Thank you for the opportunity to review the concept plan, for the Takoma Junction development – SHA Tracking #19APMO008xx in Montgomery County, Maryland. The Maryland Department of Transportation State Highway Administration (MDOTSHA) review is complete, and we are pleased to respond.

Engineering Systems Team (EST) Comments (By: Urooj Zafar):

District 3 Traffic Comments (By: Alvin Powell):

DATE: 6/3/2021	SHEET NO: 1 of 4
PREPARED BY: SH	REV BY/DATE:
CHECKED BY: AP	REV CHK BY/DATE:
SUBJECT: Intersection Sight Distance Observations Right Turn Maneuver (Eastbound)

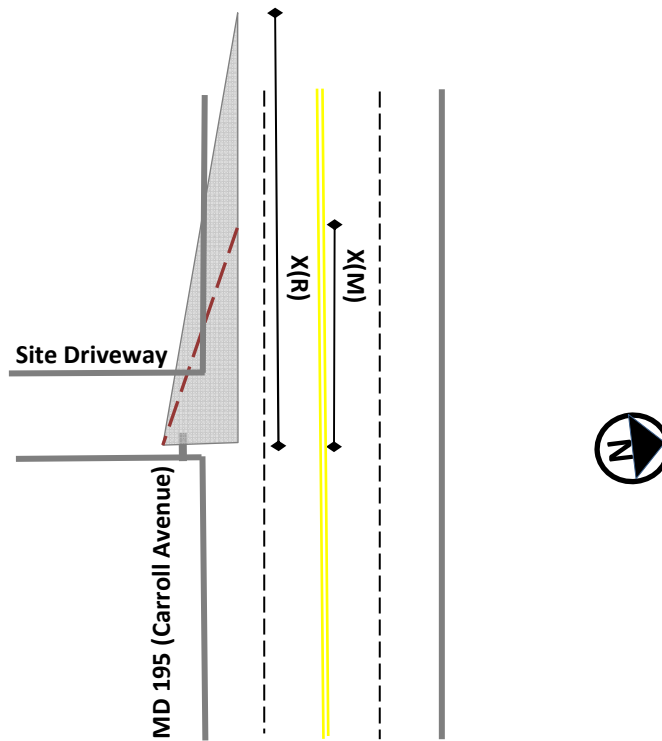
Y Stopping Distance	
X(R) Recommended	335 ft
X(M) Measured	150 ft

Measured intersection sight distance is less than recommended intersection sight distance.
Posted Speed Limit: 25 mph
Prevailing/Design Speed: 35 mph
AASHTO Greenbook, Sight Distance - Case B2: Right Turn from Stop

DATE: 6/3/2021	SHEET NO: 2 of 4
PREPARED BY: SH	REV BY/DATE:
CHECKED BY: AP	REV CHK BY/DATE:
SUBJECT: Stopping Sight Distance Observations Right Turn Maneuver (Eastbound)

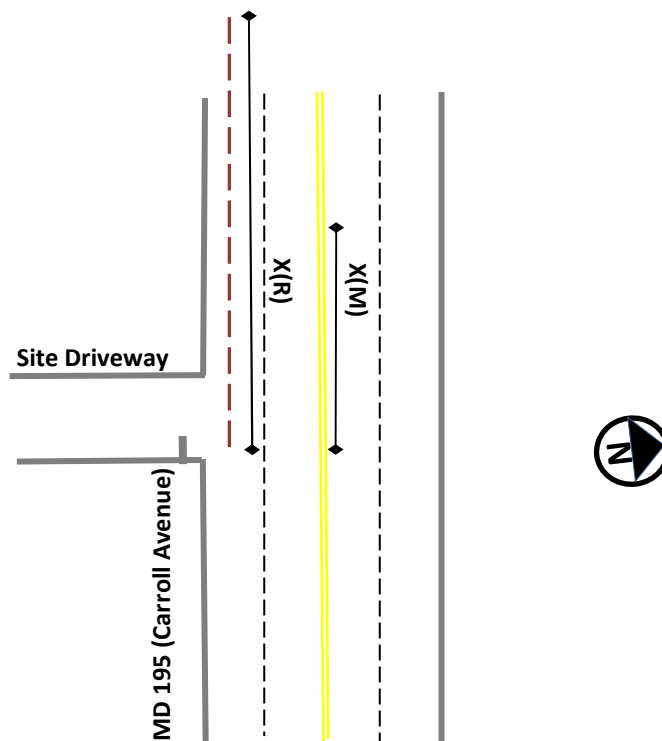
Y Stopping Distance	
X(R) Recommended	250 ft
X(M) Measured	172 ft

Measured stopping sight distance is less than recommended stopping sight distance.
Posted Speed Limit: 25 mph
Prevailing/Design Speed: 35 mph
AASHTO Greenbook, Sight Distance - Case B2: Right Turn from Stop

Picture 4 – Stopping Sight Distance Limited by Utilities and Vegetation

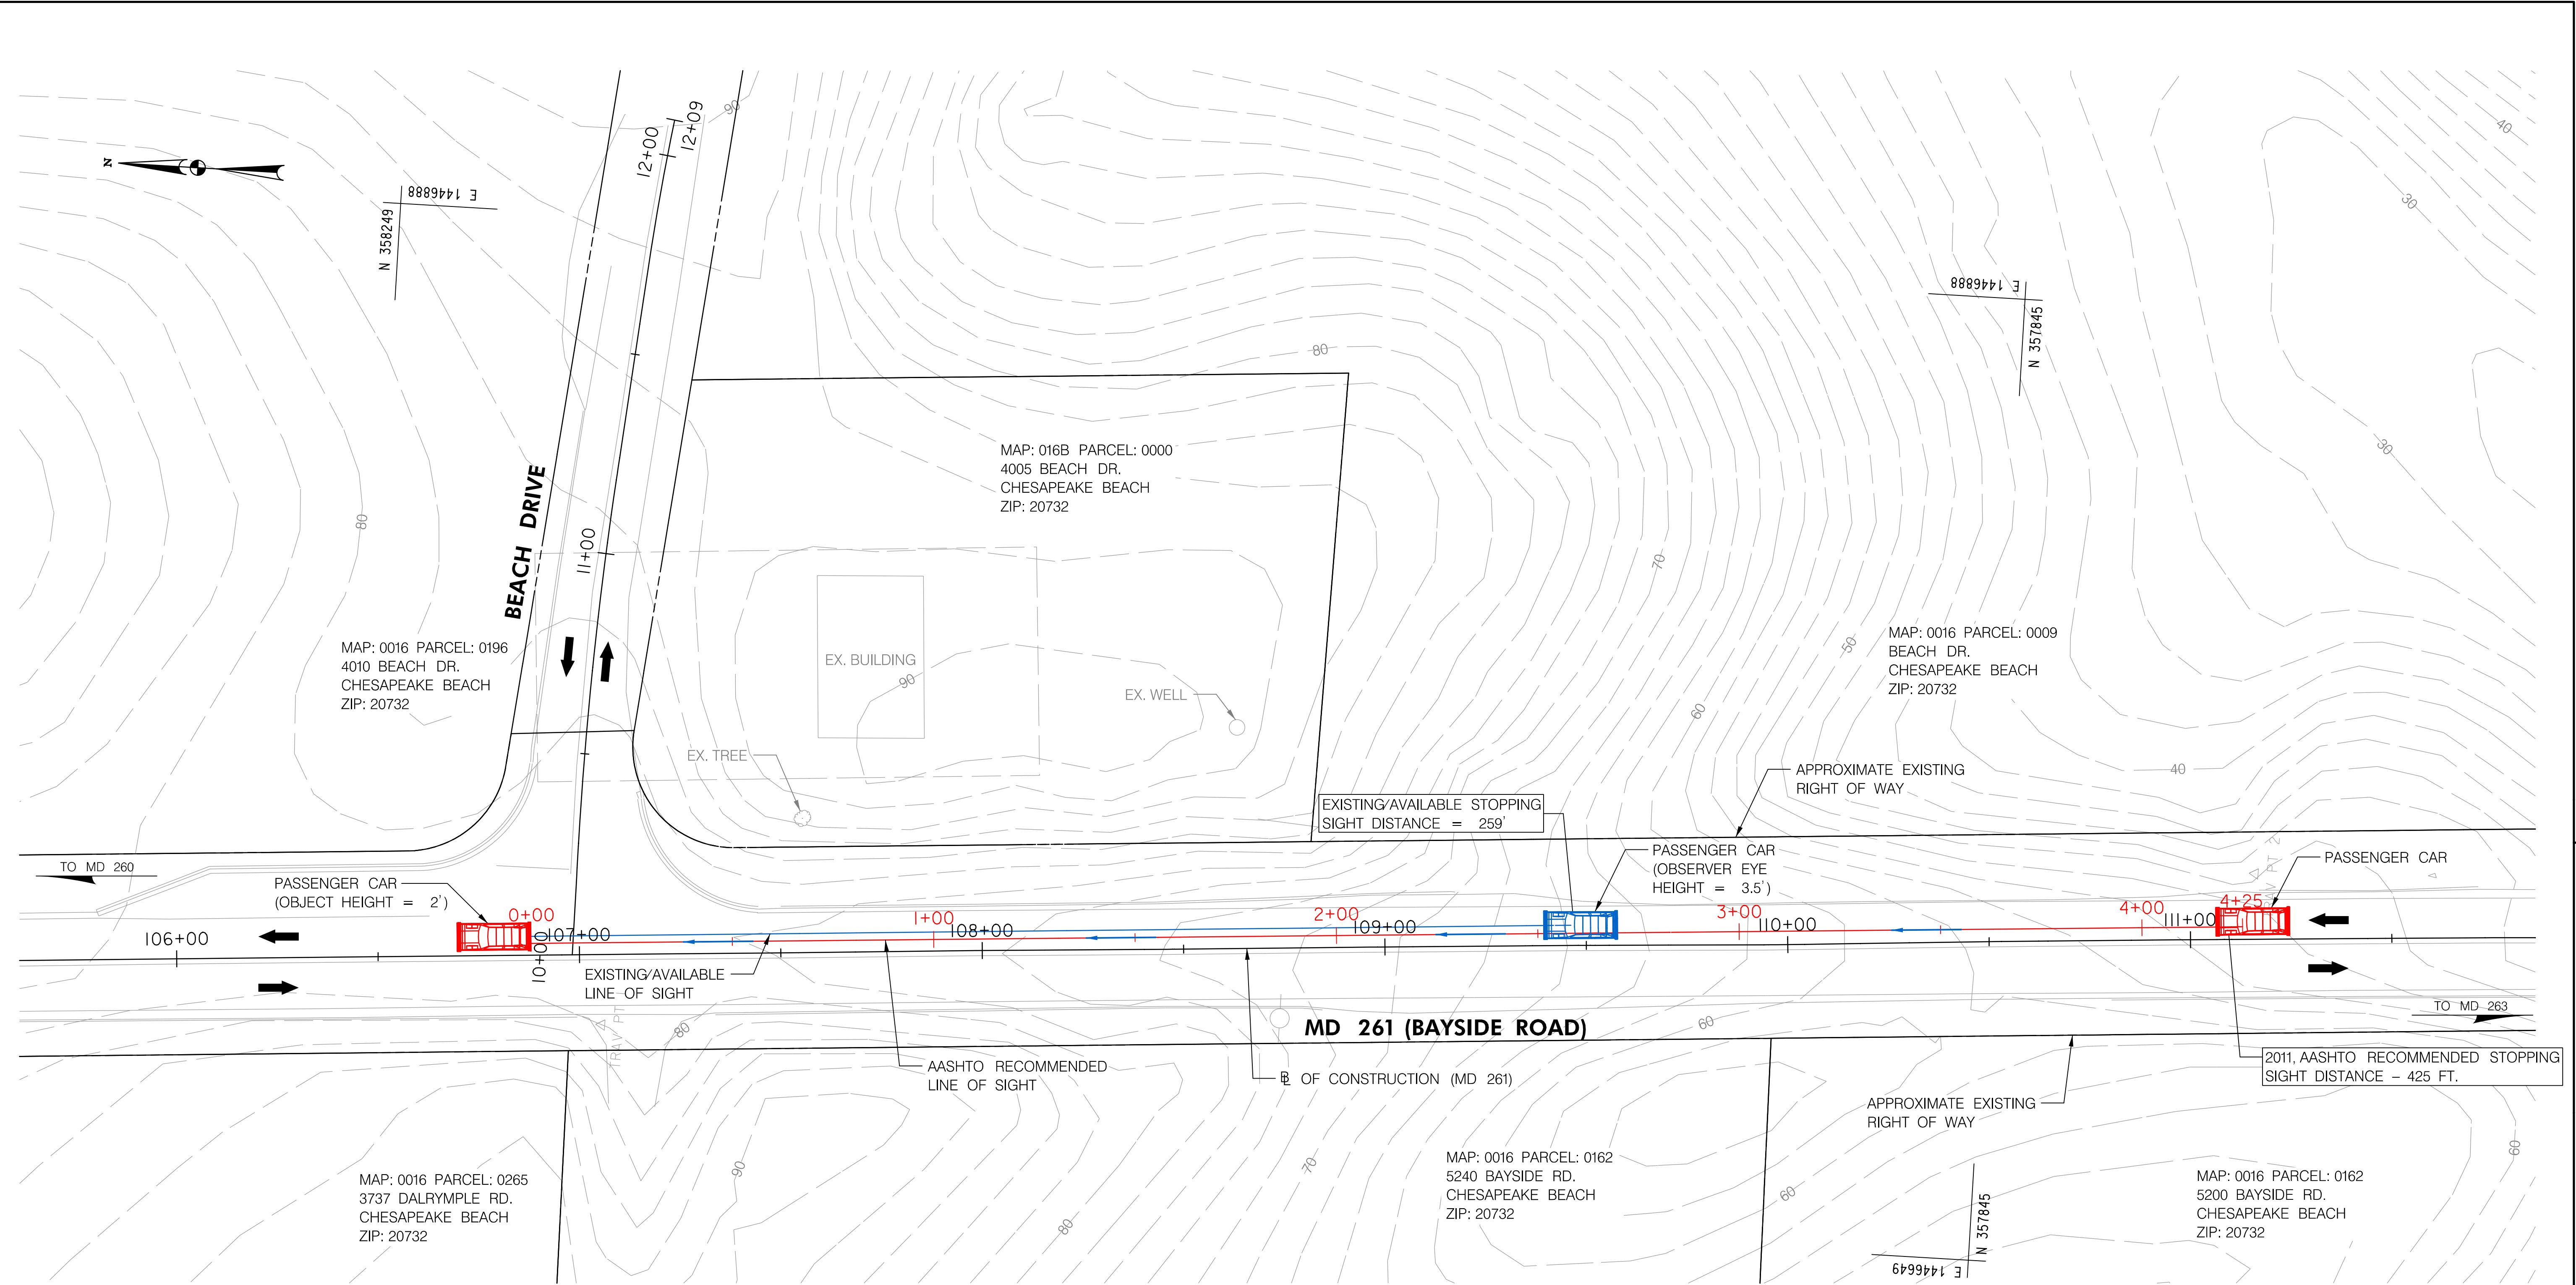
Attached to this letter are markups of previously submitted material which shows obstructions along the line of sight which prevent the reported stopping sight distance from being obtained. This includes trees and utilities. With the issues noted, we are unable to evaluate the proposed sight distance conditions and make a determination on adequacy and what measures may be available or are necessary to improve the available sight distances for the proposed access with the information provided.
